**NOTICE OF A REGULAR MEETING
BONDURANT PLANNING AND ZONING COMMISSION
OCTOBER 7, 2025**

TITLE: Resolution PZ-251007-31 - Consideration of Bondurant-Farrar Community School District Elementary Site Plan.

PROJECT NO:
24098
DATE:
08-21-2025
SHEET SET:
50% CONSTRUCTION
DOCUMENTS
SHEET NAME:
GRADING PLAN

SHEET:
A2.01
Copyright ©2025

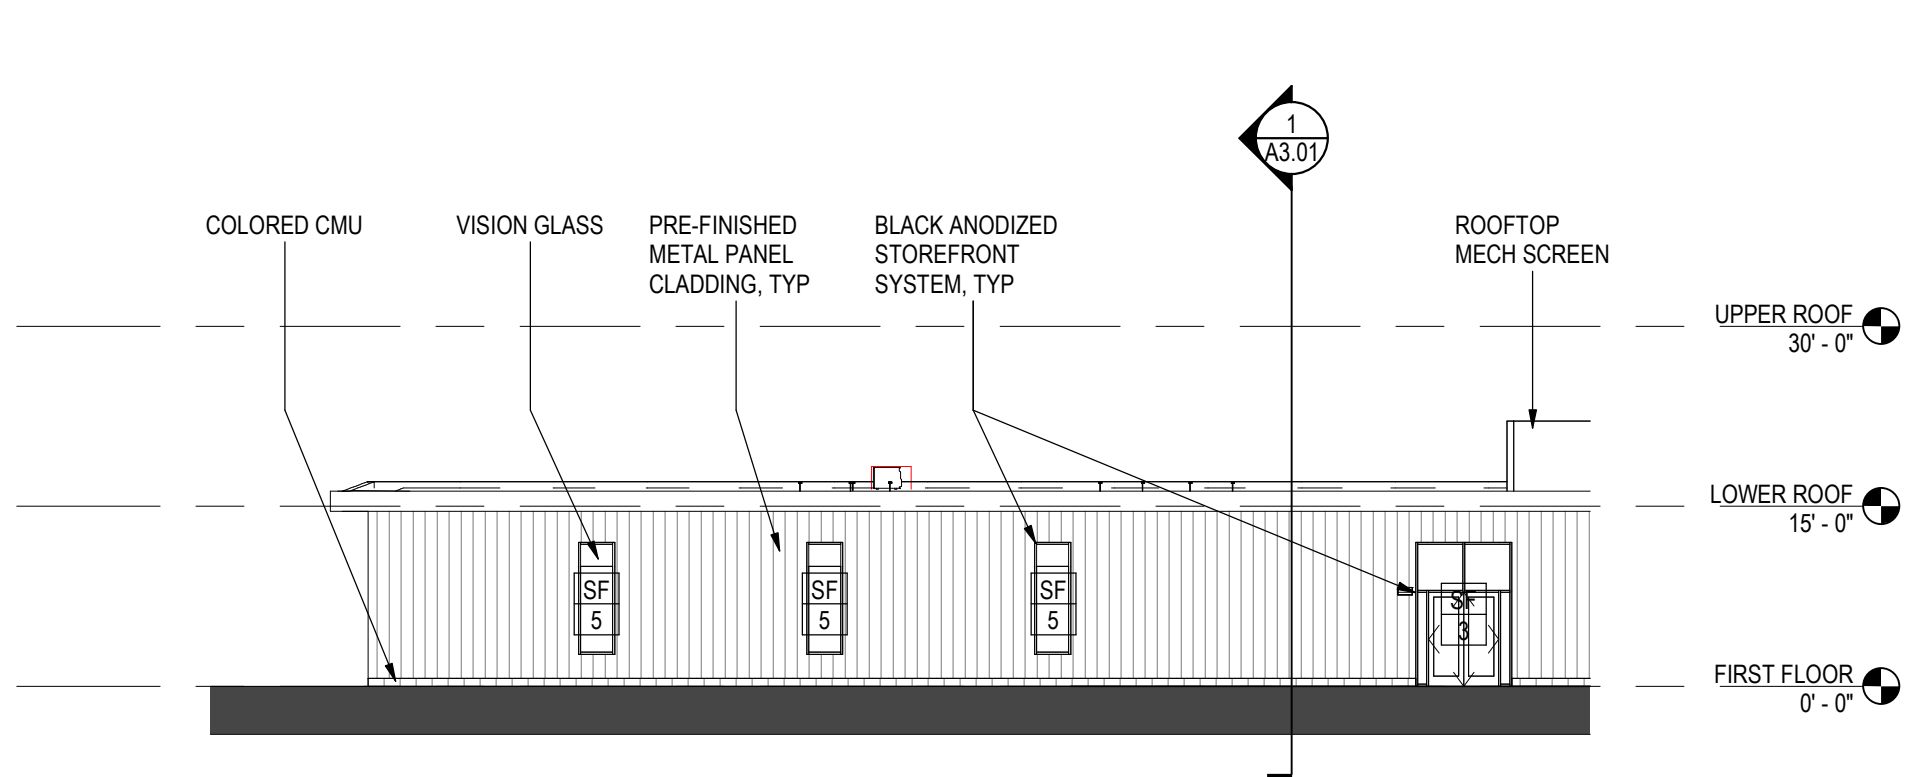
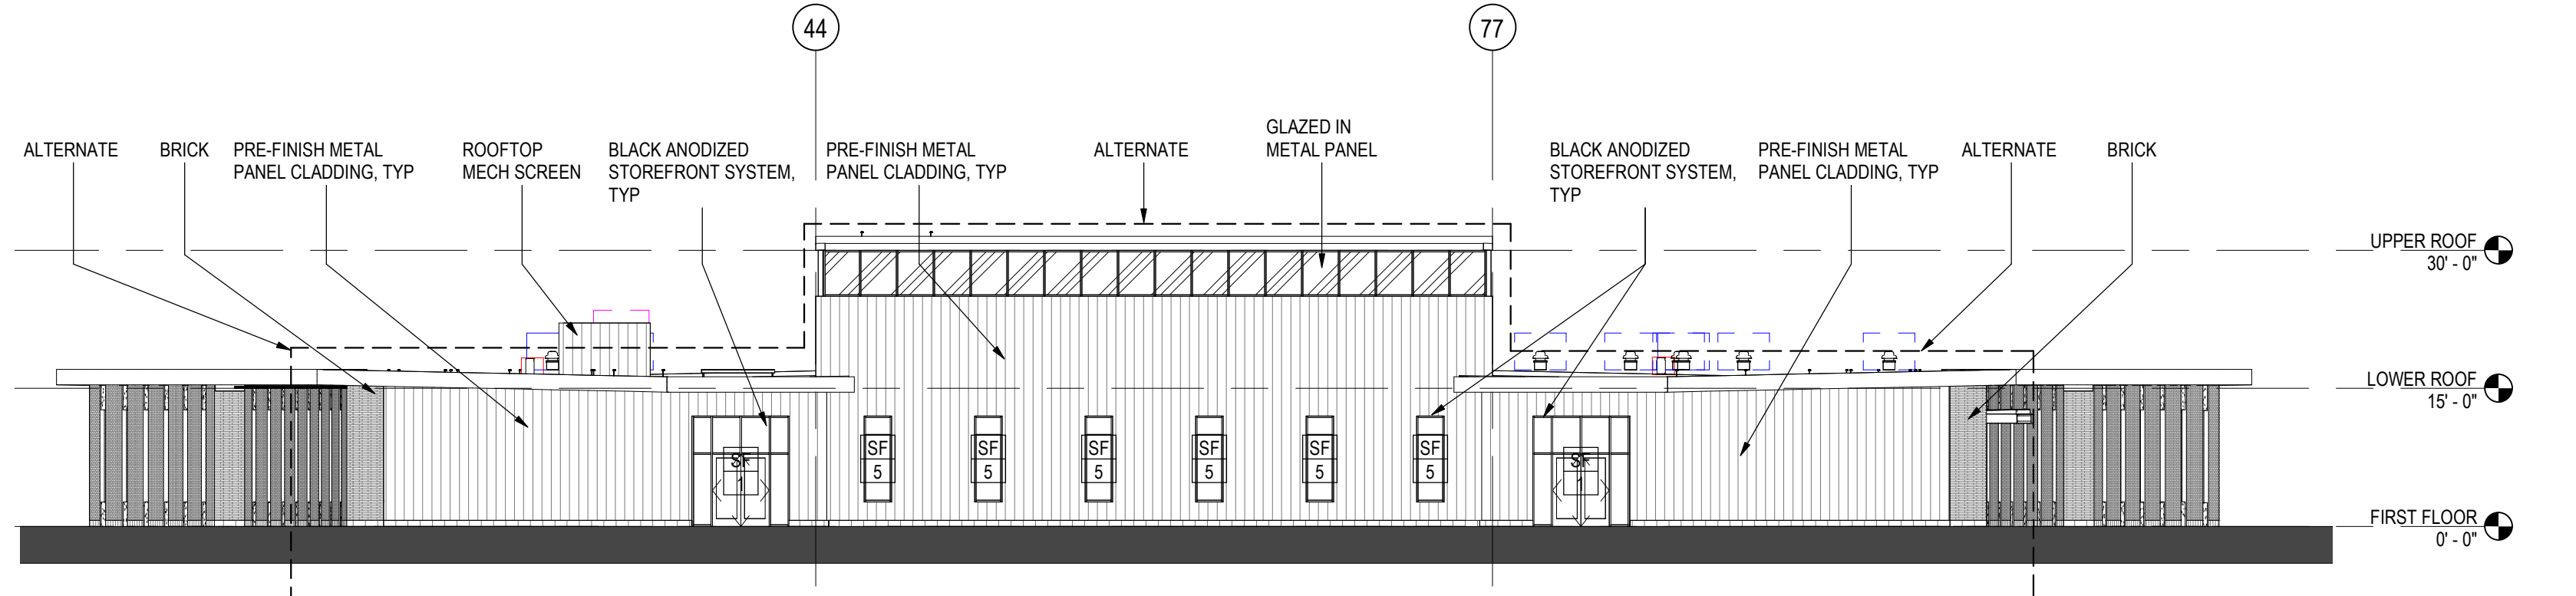
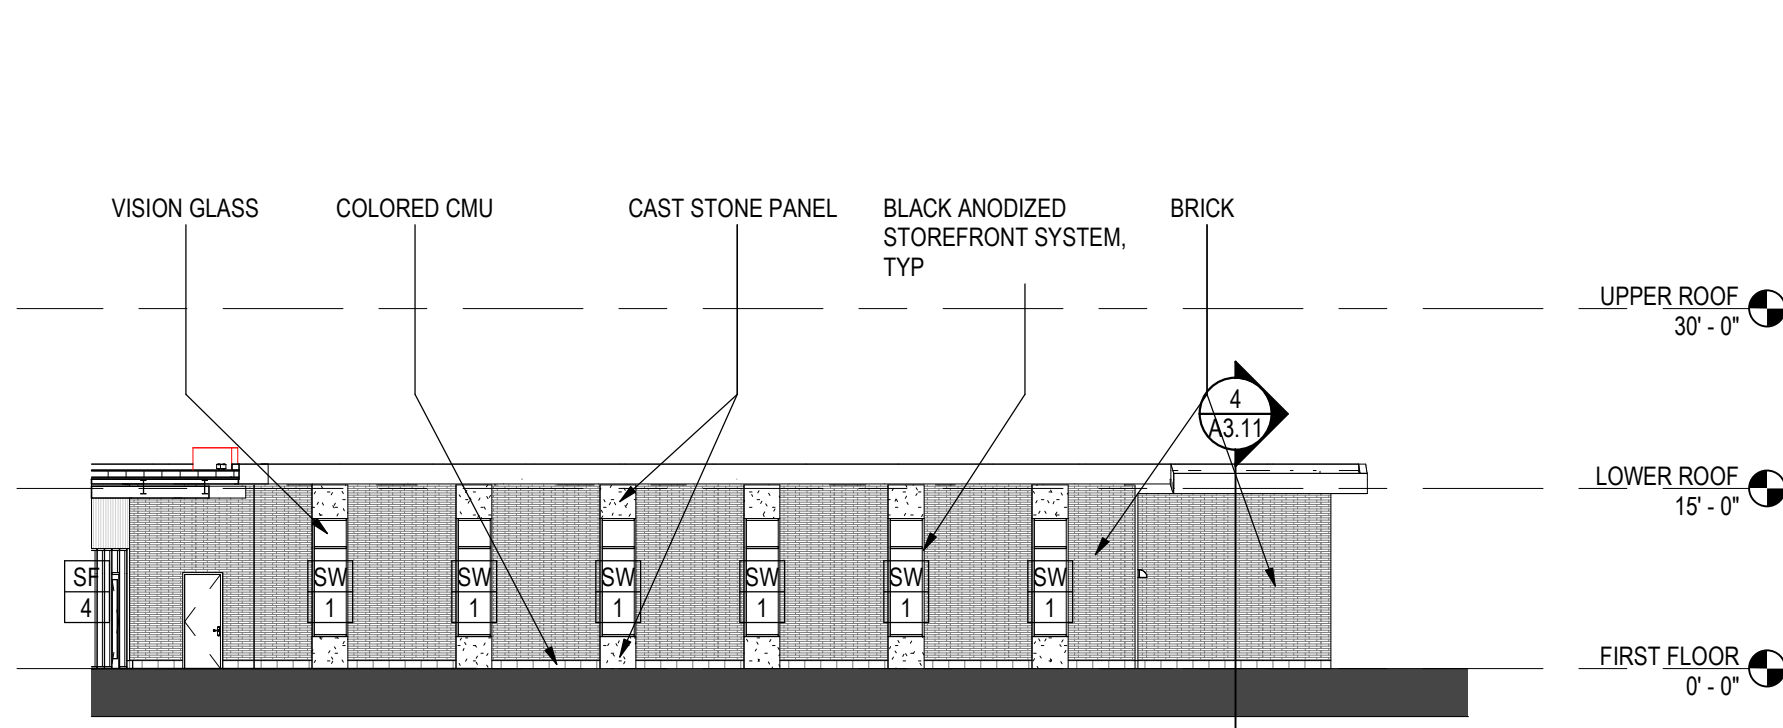
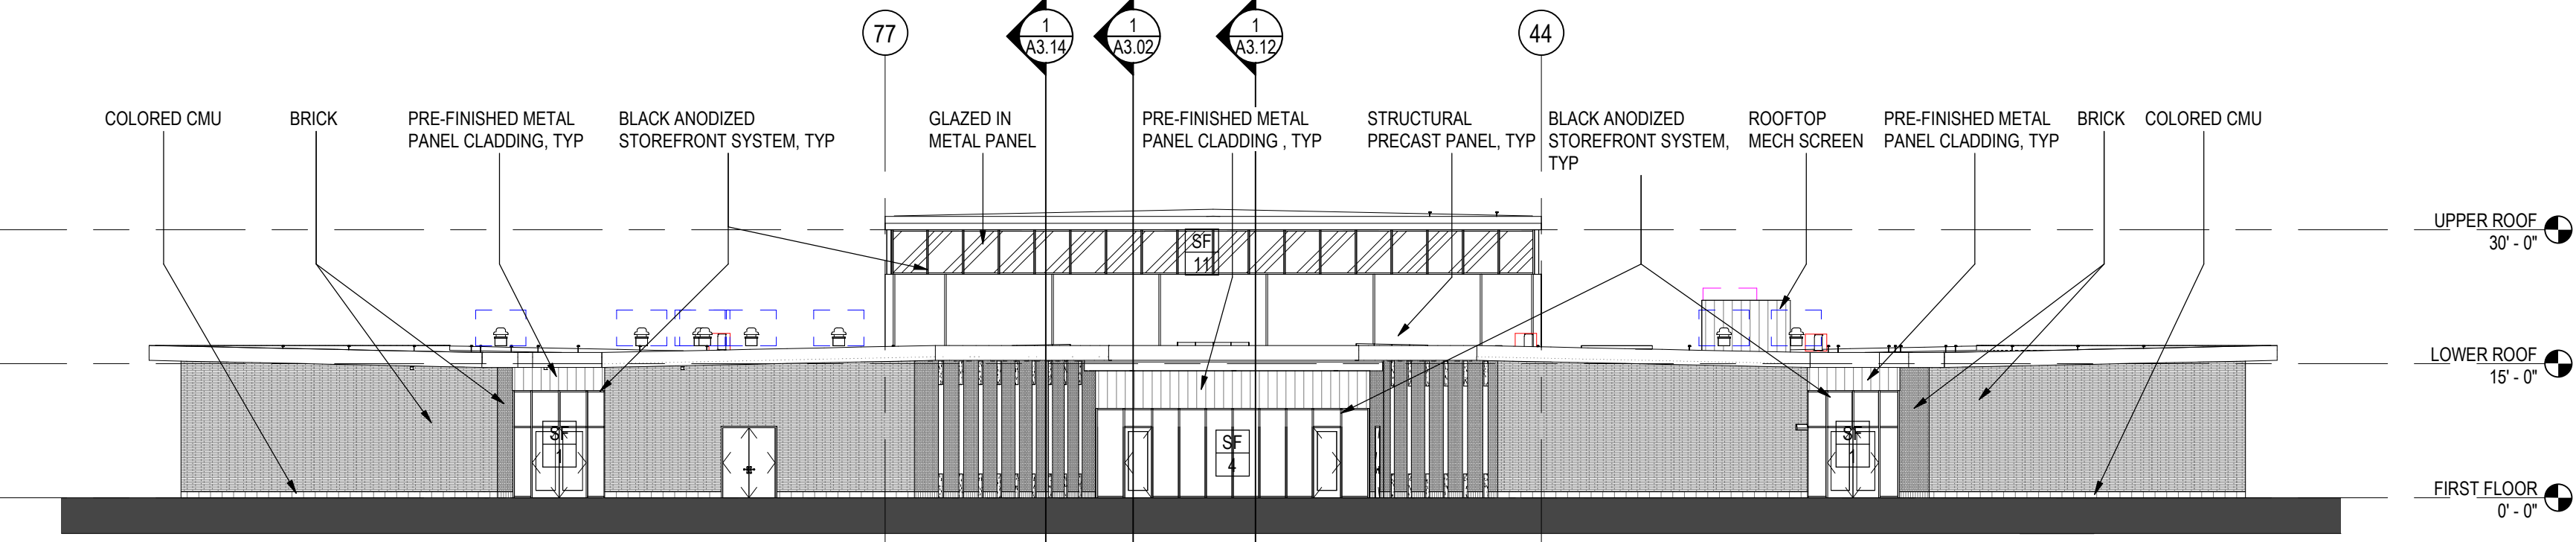
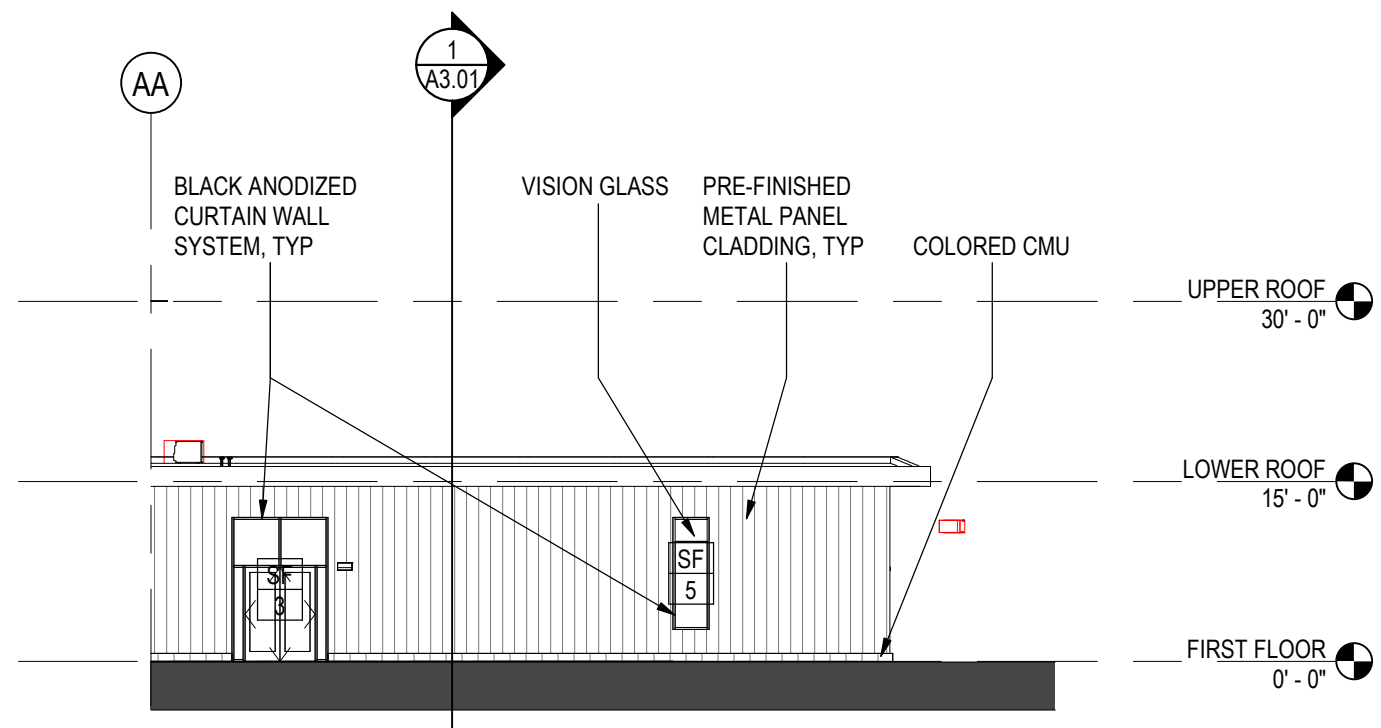
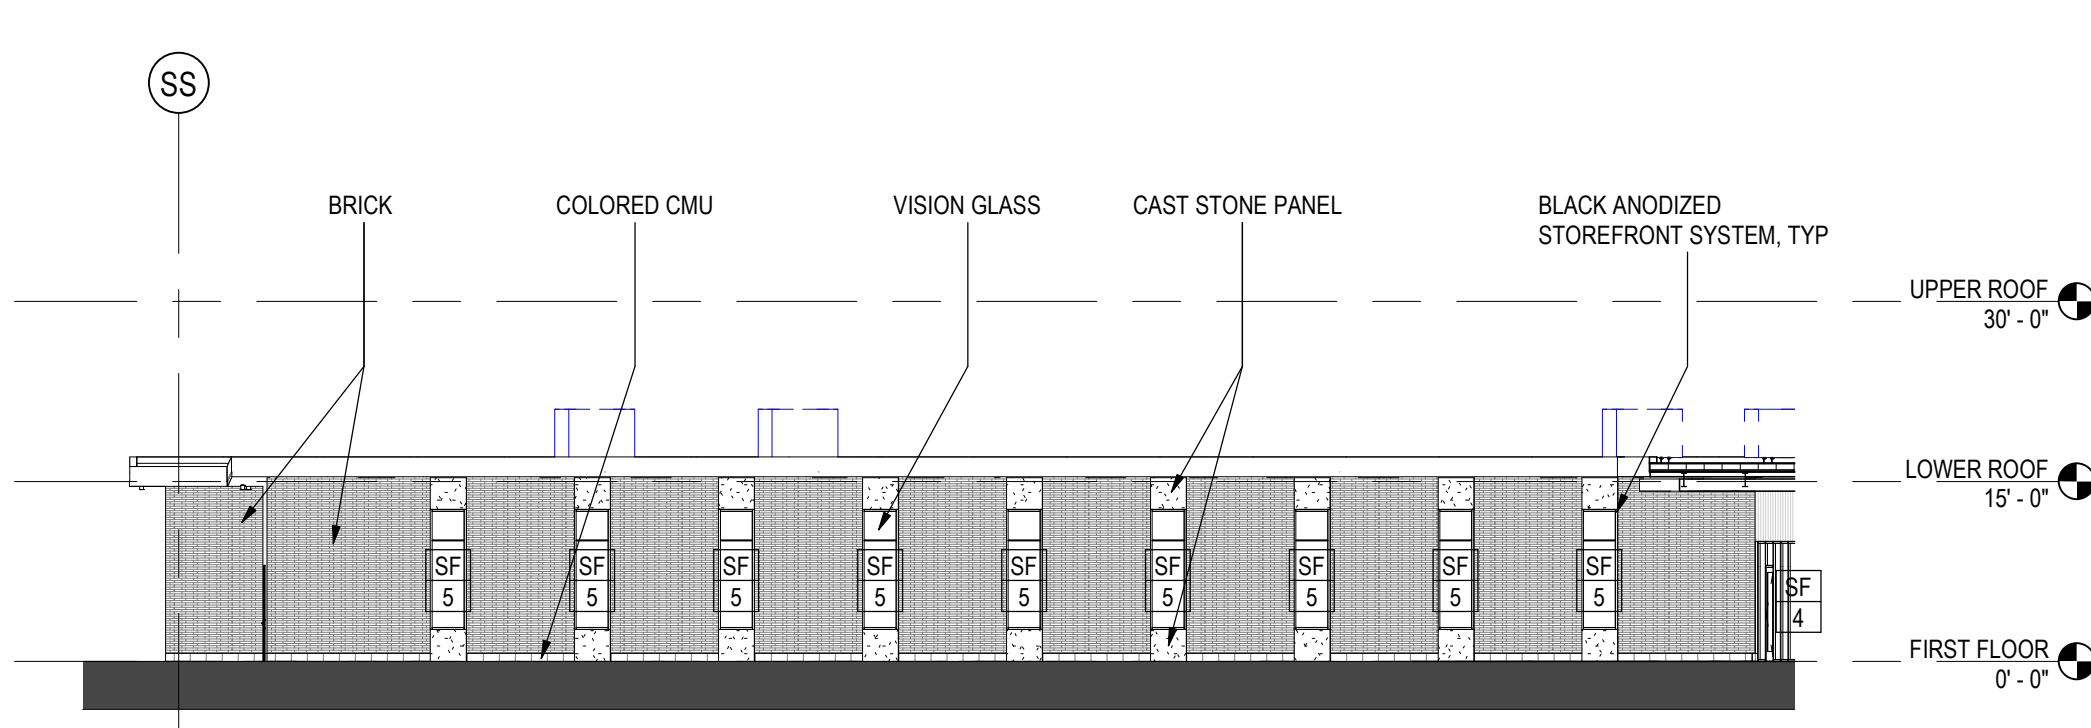
- Architectural elevations have been submitted to staff and appear to meet the architectural design standards. The submitted architectural elevations do not include a percentage breakdown of proposed building materials. The site plan shall be updated to include this breakdown.
